Debtors' Letter to BP, Dated November 3, 2020

Re: Genovesa Single Flowline Plan to mitigate impact from ongoing diagnosis and potential remediation on the Loop

Genovesa Single Flowline Plan

Prepared by Fieldwood Energy LLC (October 30, 2020)

Figure 6 – New Jumper Configuration

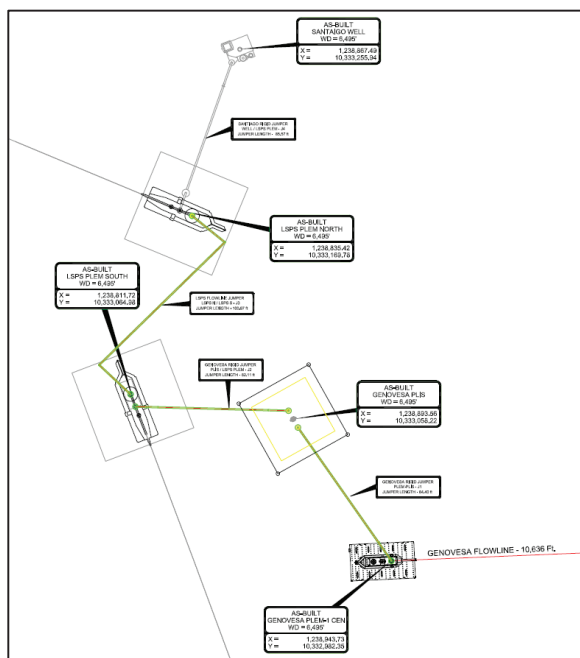
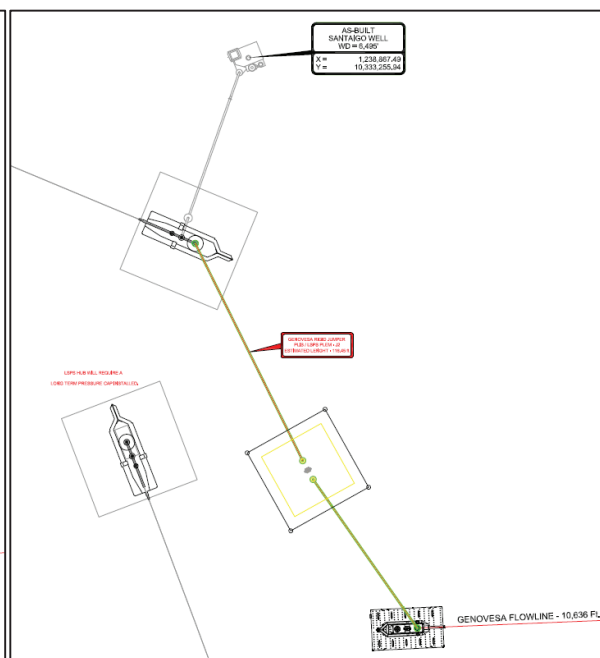
1. Fieldwood and BP jointly develop and agree on engineering design, flow assurance, operating procedures, regulatory plans and subsea operations;
2. BP flushing the jumper between Santiago PLEM-1 and Santiago PLEM-2 with methanol from the Santiago tree;
3. Fieldwood removing the jumper between Santiago PLEM-1 and Santiago PLEM-2 and installation of pressure caps and the jumper between the Genova PLIS and Santiago PLEM-1;
4. Fieldwood installing a new jumper between the Genova PLIS and Santiago PLEM-2 jumper, including flushing and testing and startup of Genova and/or Santiago; and
5. Fieldwood and BP ongoing joint development and implementation of plans for Loop remediation (including recovery, repair and/or reinstatement)

The Genovesa Single Flowline Pan will require no changes to the original flow assurance strategy, except for a review of the hydrate management strategy. Operating procedures will identify the Genovesa well in the normal operations, system start up, and planned and unplanned shutdown sequences.
